BURLINGTON DEVELOPMENT REVIEW BOARD

Tuesday, October 6, 2015

MEMORANDUM

To: Development Review Board
From: Mary O'Neil, AICP, Senior Planner
Date: October 6, 2015
RE: ZP16-0263CA 584 South Prospect Street

### LANDSCAPE PLAN

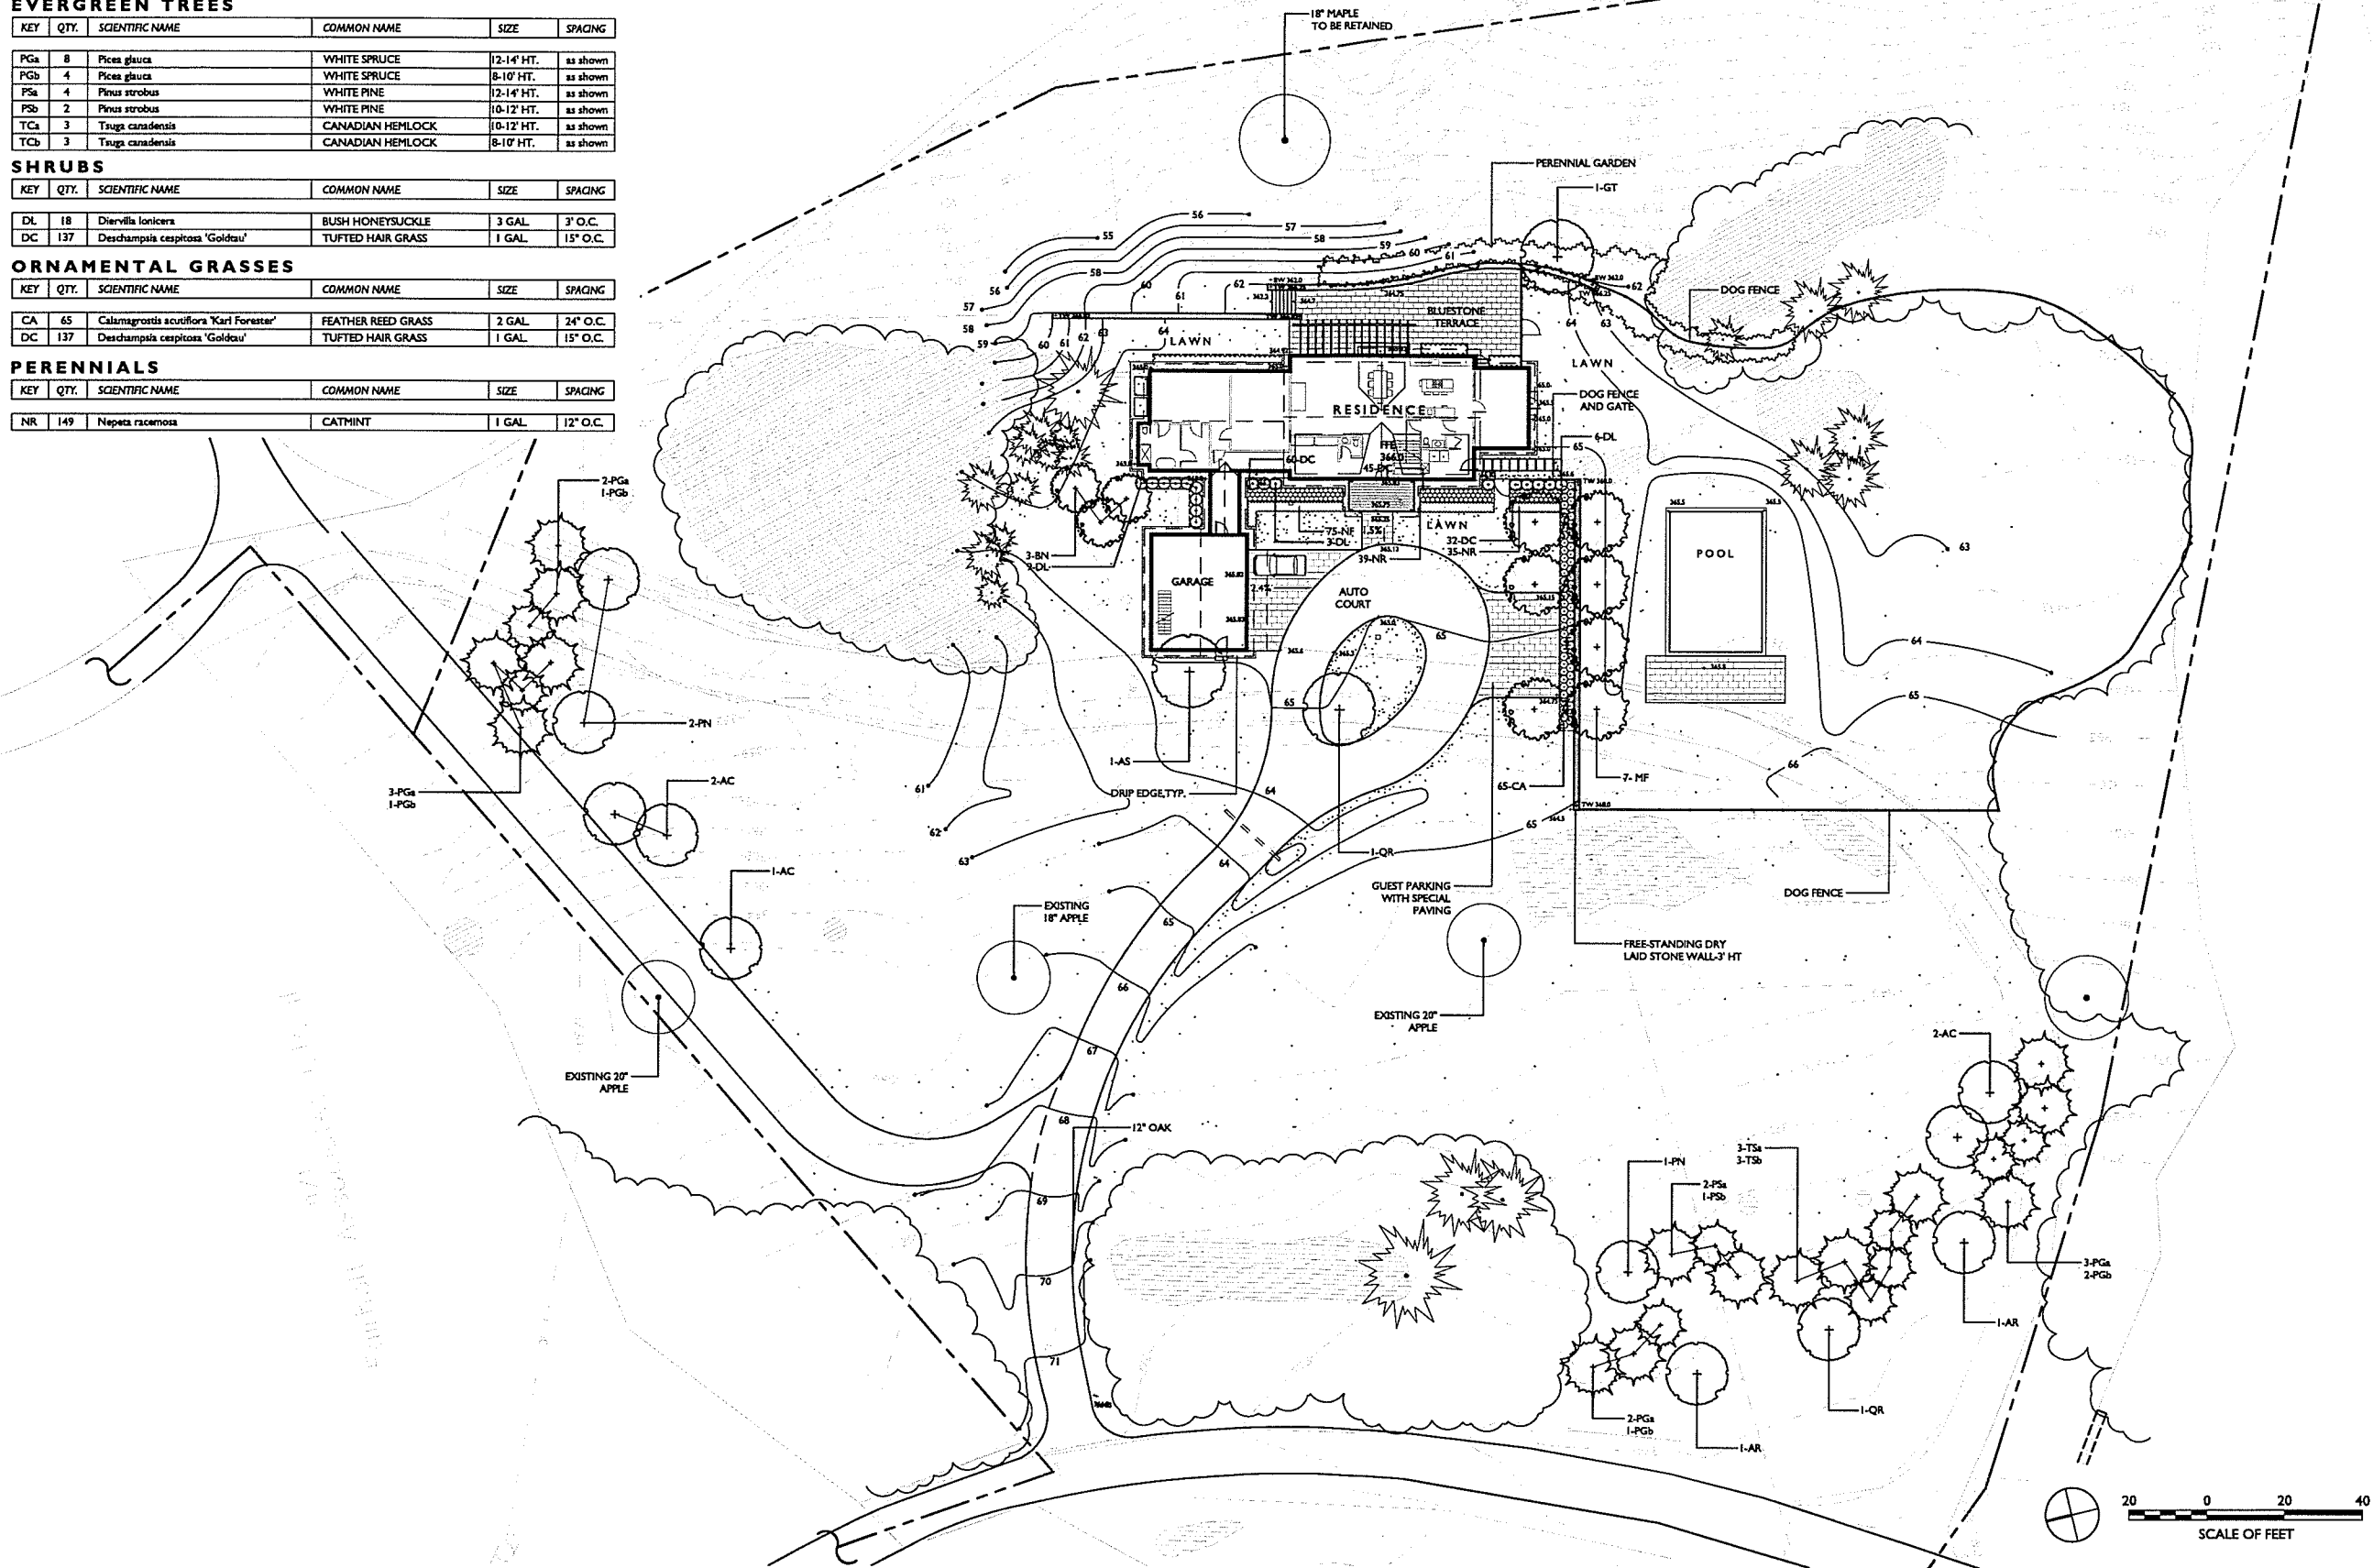
Plan L1.1 defines tree removal in the intended location of new structure. The majority of trees proposed for removal are pines. When reviewed in concert with Plan L1.0 (Landscape Plan), the tree removal appears consistent with the overall site and development plan, which includes a robust planting schedule. **Affirmative finding.**

A landscape plan has been provided (L1.0), and is accompanied by a separate tree removal plan (Plan L1.1.) See Section 5.5.4, above.

A dog fence is identified on the plans, as well as free standing dry laid stone retaining walls. If the dog fence is above ground (rather than an “invisible” electronic fence), more detailed information about that fence will be required. (Height, material, style.) Any retaining wall exceeding 3’ in height will require review and approval by the city engineer.
